## HISTORIC AND DESIGN REVIEW COMMISSION

November 03, 2021

**HDRC CASE NO:** 2021-532  
**ADDRESS:** 210 E RISCHÉ  
**LEGAL DESCRIPTION:** NCB 2557 BLK D LOT 3  
**ZONING:** RM-4  
**CITY COUNCIL DIST.:** 1  
**DISTRICT:** Nathan Historic District  
**APPLICANT:** Mario Salinas/MDB Architecture  
**OWNER:** Florencio Maya/RM Construction Group  
**TYPE OF WORK:** Exterior alterations, lighting, window replacement, roof replacement  
**APPLICATION RECEIVED:** October 13, 2021  
**60-DAY REVIEW:** Not applicable due to City Council Emergency Orders  
**CASE MANAGER:** Katie Totman

1 EAST ELEVATION  
3/8" = 1'-0"

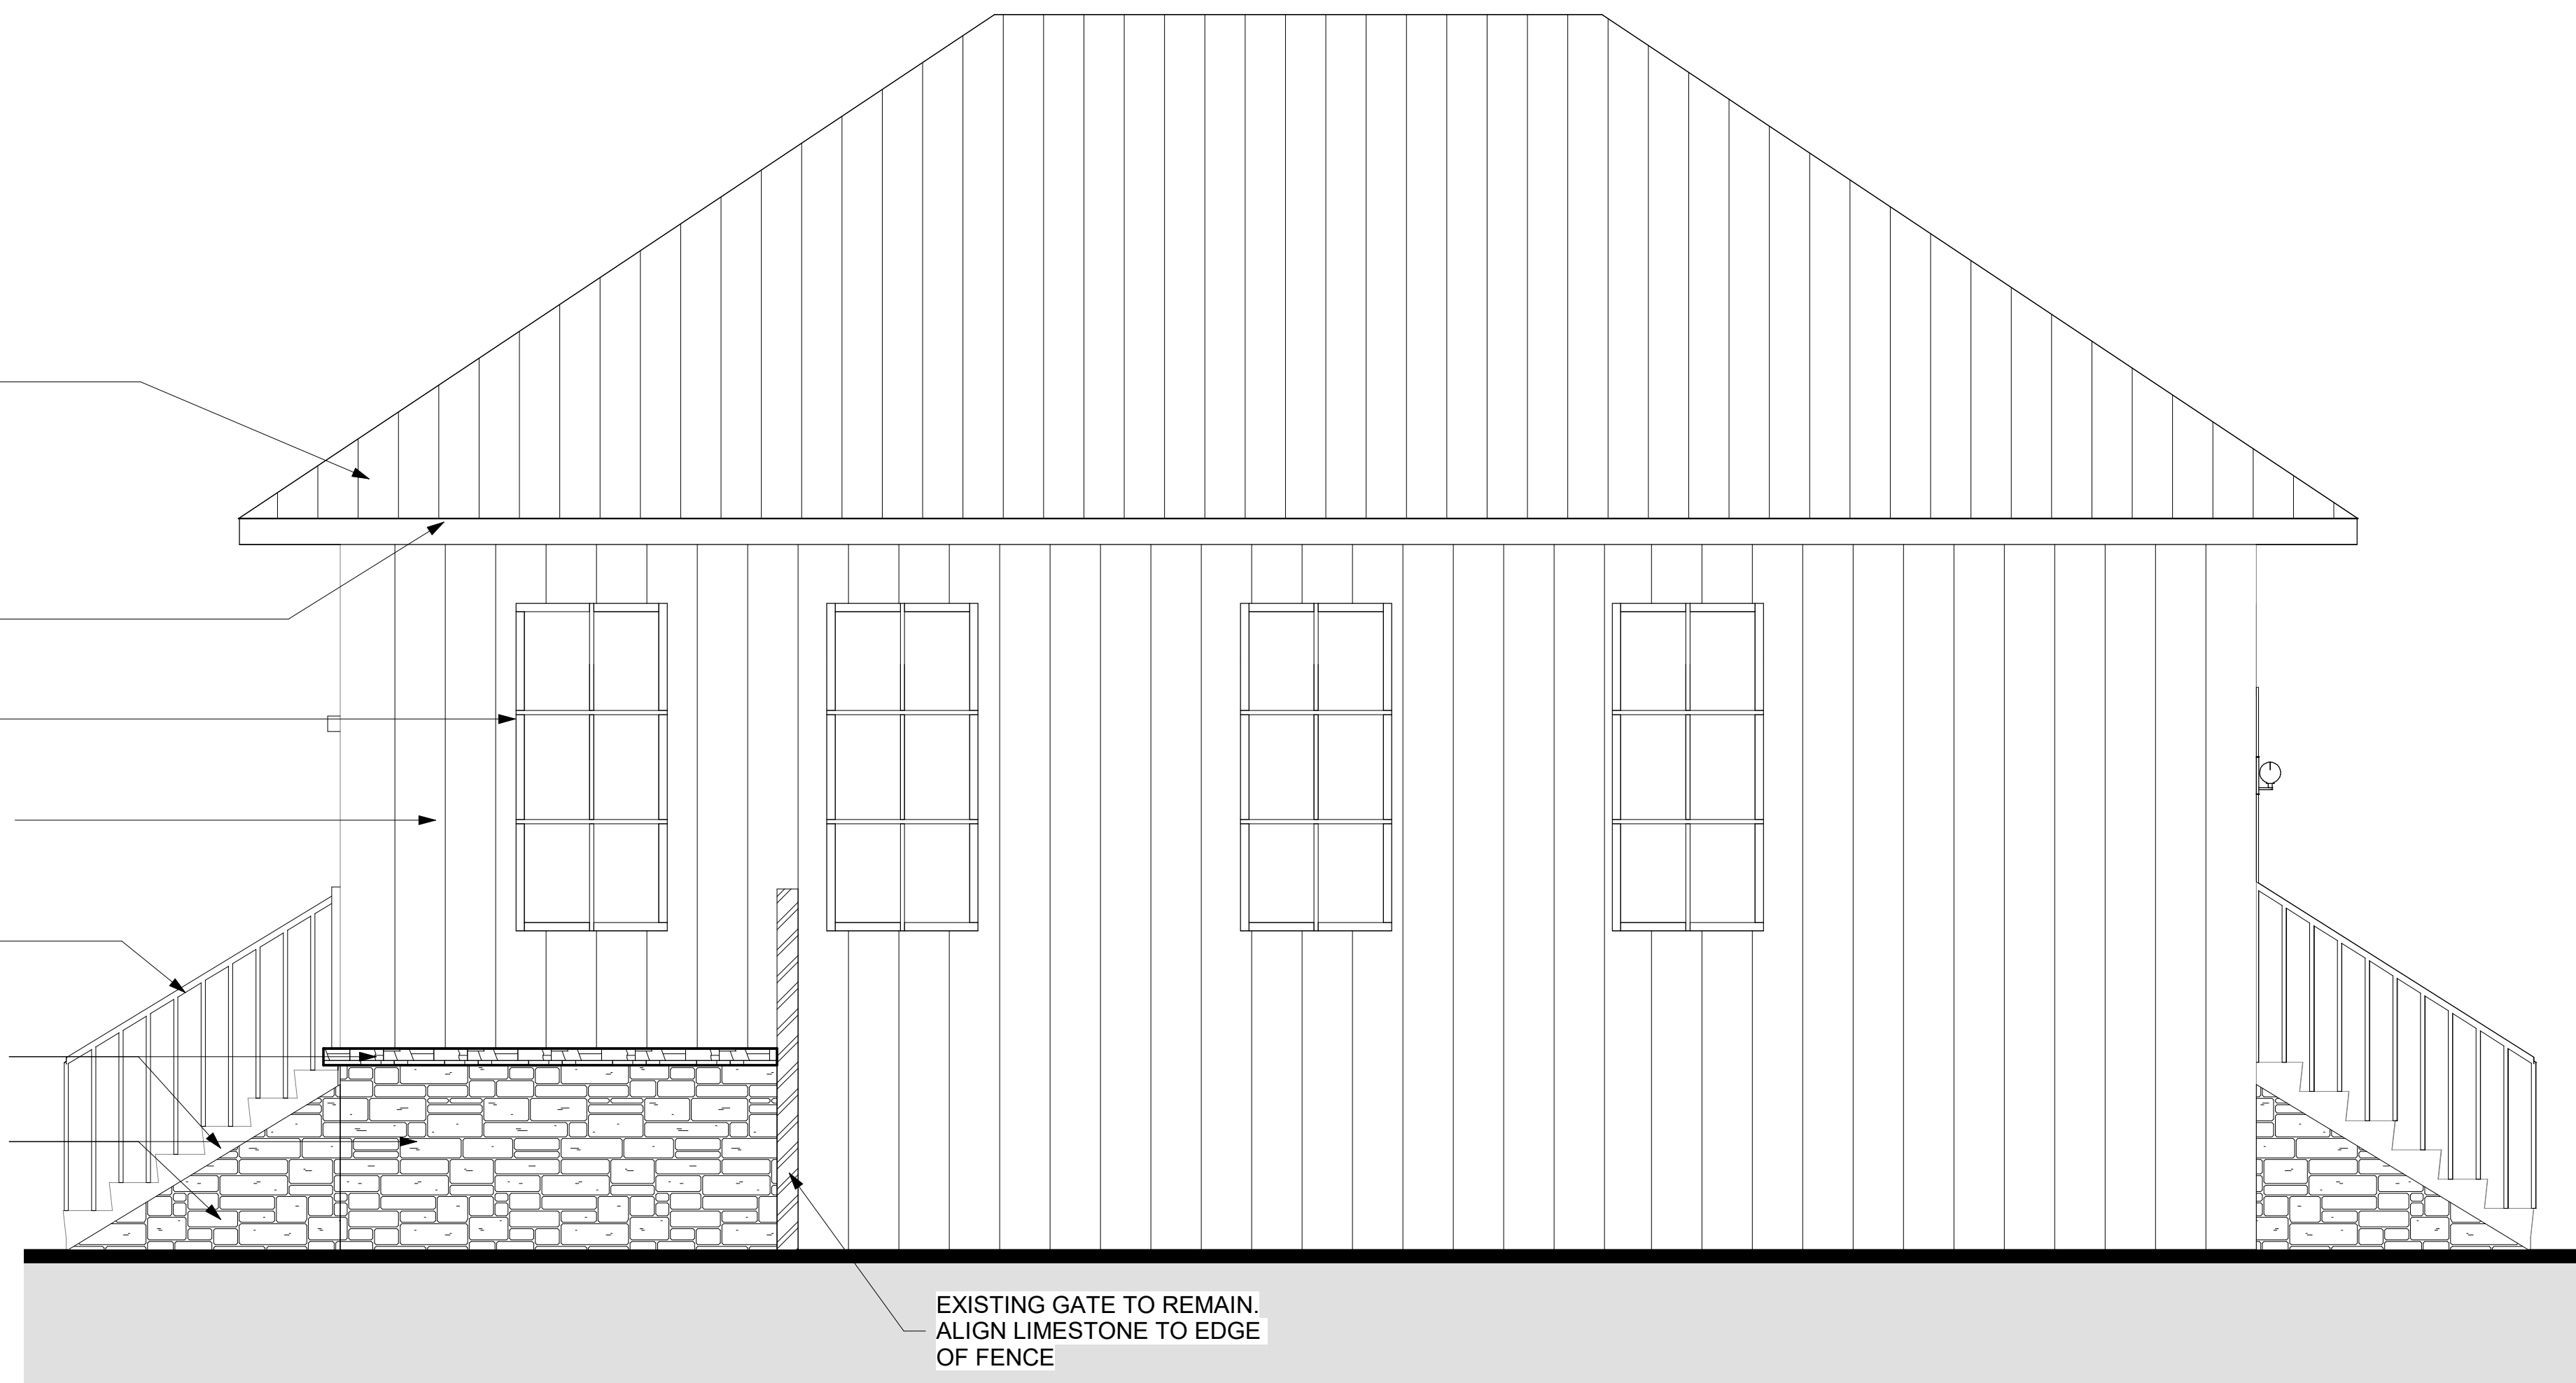
h. FENESTRATION MODIFICATIONS – The applicant has proposed to remove one (1) existing wood window from the east elevation of the main house and enclose it with siding. According to the Guidelines for Exterior Maintenance and Alterations, 6. A. i., preserve existing window and door openings. Avoid enlarging or diminishing to fit stock sizes or air conditioning units. Avoid filling in historic door or window openings. Avoid creating new primary entrances or window openings on the primary façade or where visible from the public right-of-way. This request is not consistent with the Guidelines.

Item 4: The removal of the wood window on the east elevation and enclosing with siding. Staff recommends maintaining this window opening to be consistent with the design guidelines.
